Planning Commission Work Session

RZN22-0004 Glade Spring Crossing

- Request
 - Rezone 44+ acres from RR-1 to PR
 - Construct public streets
 - Develop single- and attached-family dwellings
 - 176 units (appx. 4 units per acre)
 - Mix of restricted affordable and market-rate housing
 - Regional stormwater management
 - Major subdivision public hearing to follow if approved

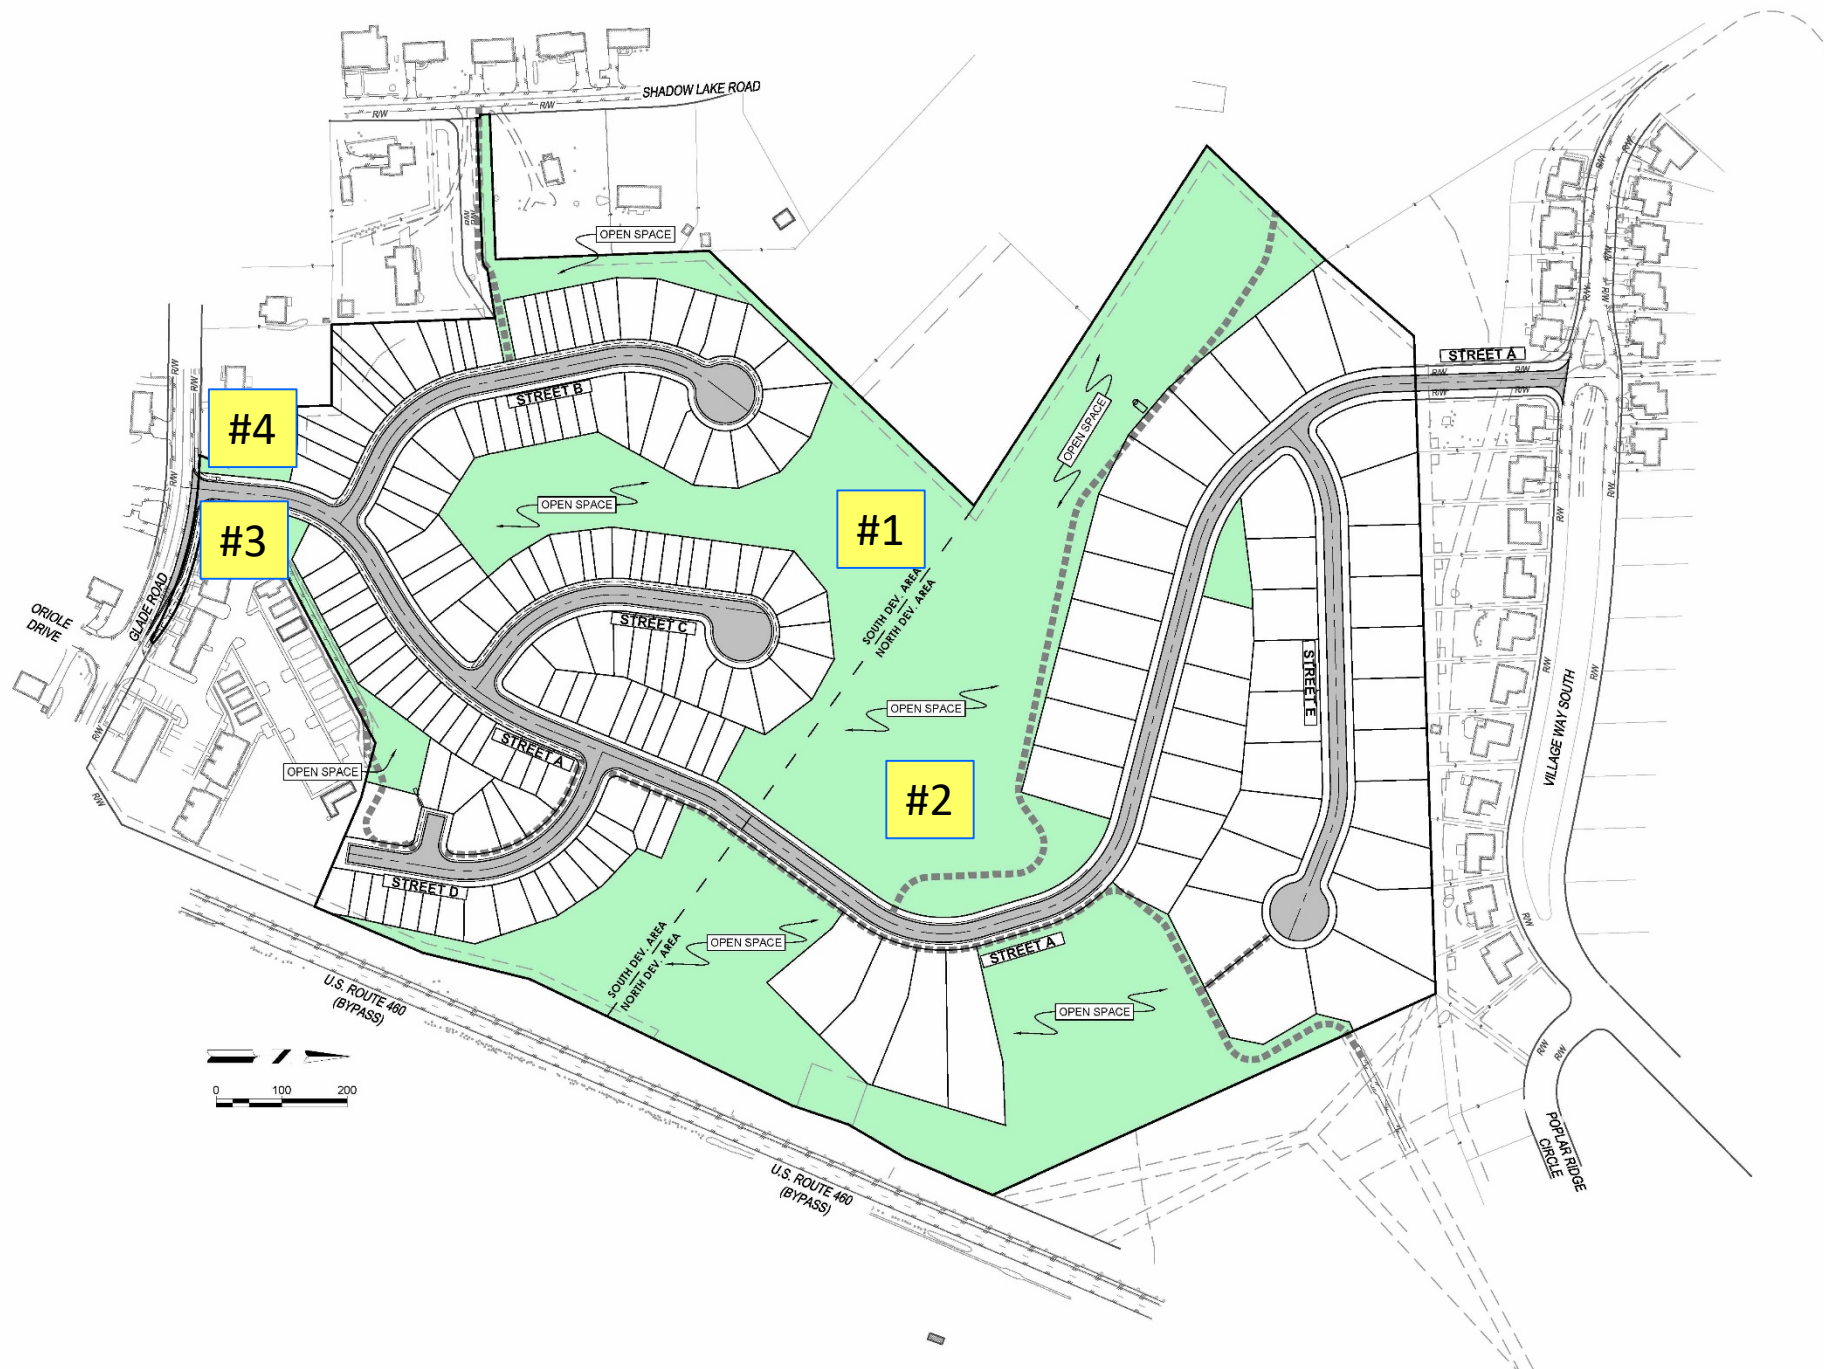
- Perimeter Setbacks
 - PR district states that perimeter setbacks shall be equivalent to neighboring zoning, or as “deemed appropriate during the review and approval of the master plan for the PR district”
- Application does not specifically address perimeter setbacks
- Rear yards of homes comprise the perimeter of the development
 - North area rear yard minimum setback: 20’
 - South area rear yard minimum setback: 10’

- Open Space
 - PR district and Townhome Use & Design Standards require minimum 20% open space
- Applicant proposes 35% open space
 - Two large blocks and two small blocks
 - Recreation amenities

SITE DRIVEWAY CONCEPT
 GLADE SPRINGS
 SITE CONCEPTS

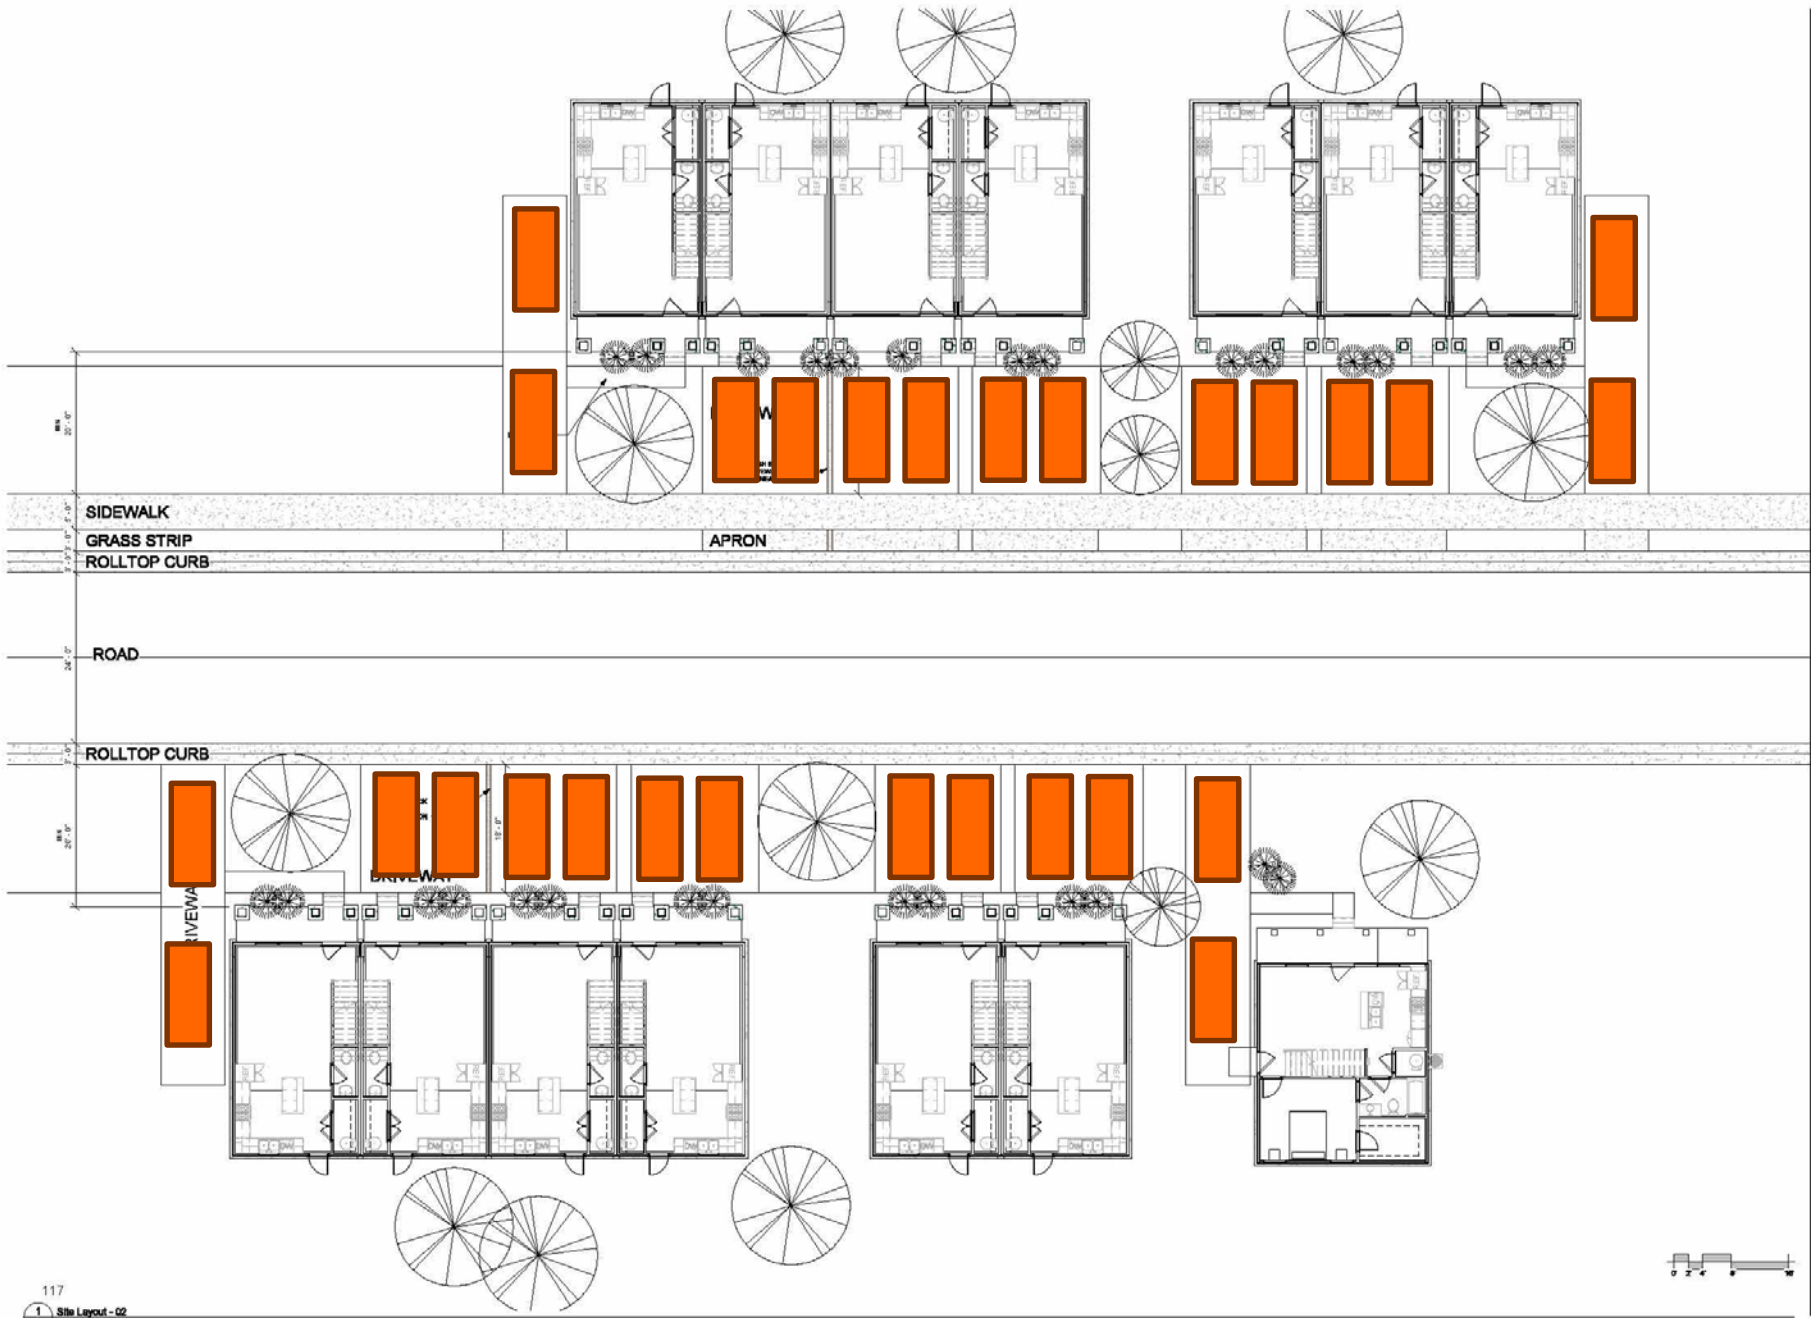
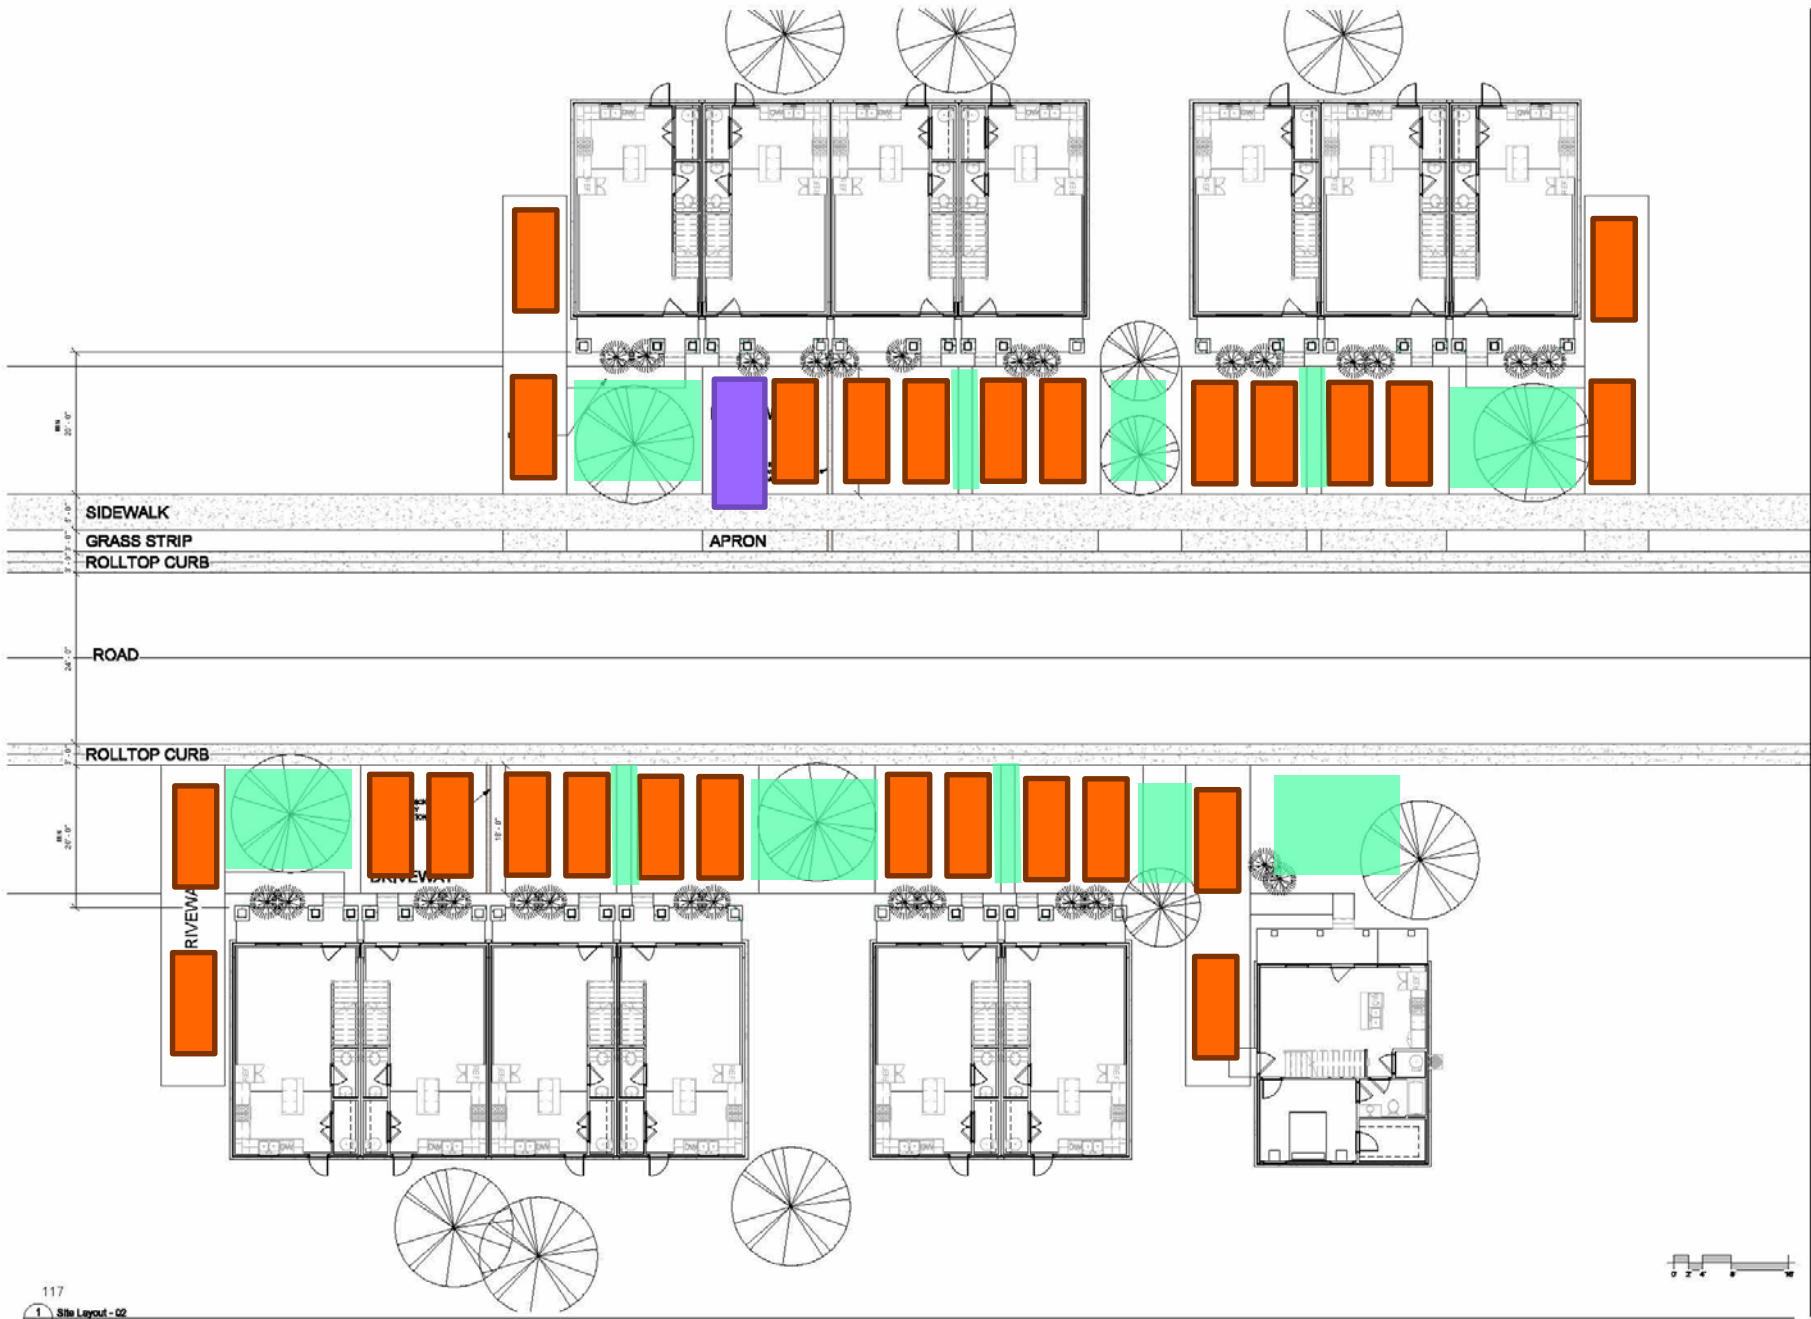
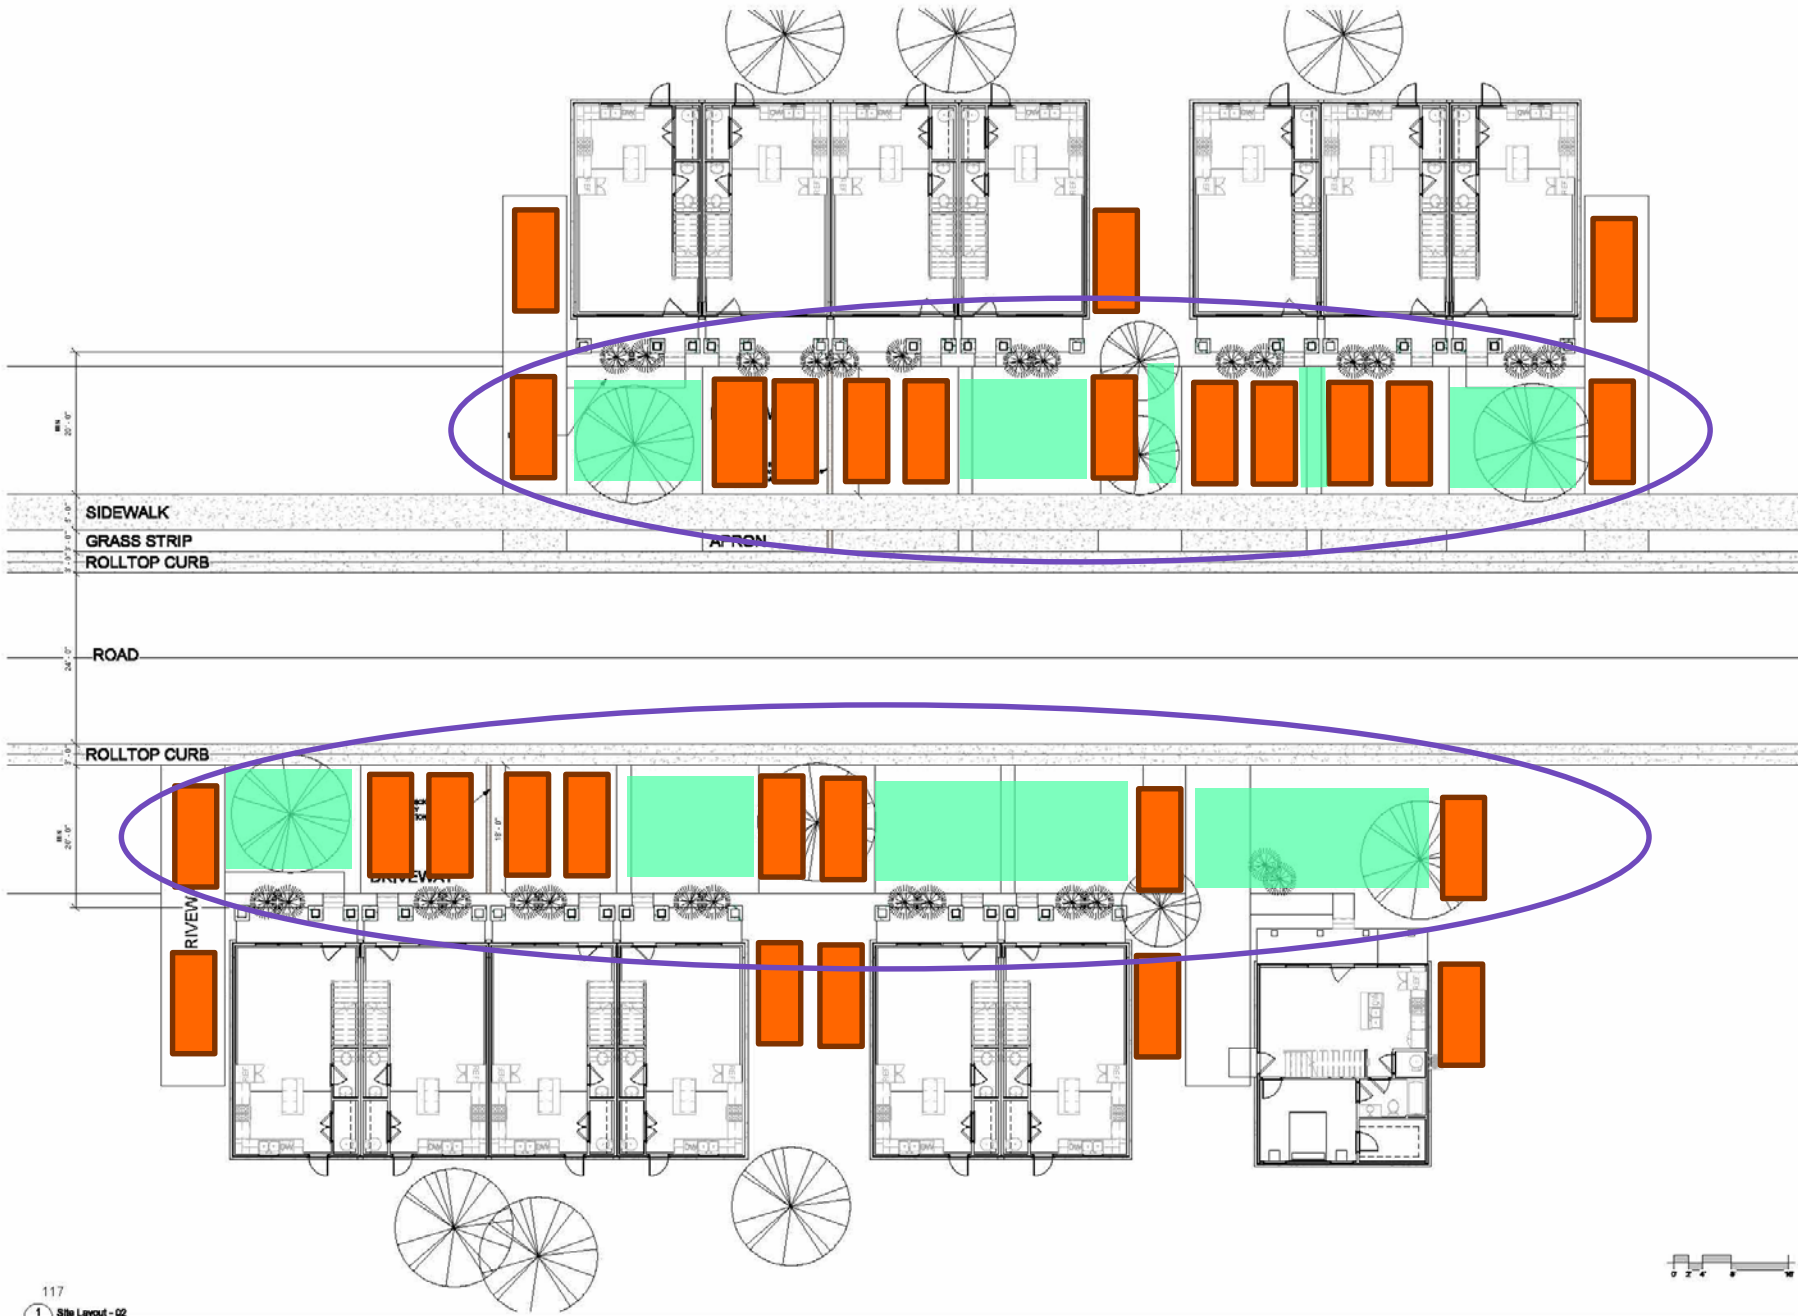
- Townhomes & Two-family dwellings
 - Parking must be located behind the front building line
- Proposed layout provides parking for most units entirely in front
 - Applicant has not specifically requested an exception to this standard

- Parking is required to be off-street in a parking lot or driveway
- Single-family detached, and subdivided two-family dwellings may maneuver in or back into the street
- Parking for all other uses must be accessed via driveway that does not require maneuvering or backing in the street
- As proposed, parking for all units requires backing or maneuvering in the street

- Driveways required to be 3' from property line unless shared for multiple uses
 - Applicant proposes a standard for 0' driveway setback, even for non-shared driveways
 - Applicant states that minimum lot frontage of 18' provides minimum parking width for 2 cars

- Overall effect of proposed layout and needed modifications to standards produce a streetscape that is more similar in appearance and feel to a multifamily parking lot than a mixed-residential street with individual units.
- Little or no greenspace provided for some interior units in front yard
- Multiple driveway entrances close together may affect safety due to sight distance on horizontal and vertical curves in the street design
- Additional considerations for shallow front yards that vehicles may overhang the public sidewalk if not enough depth for parking is provided
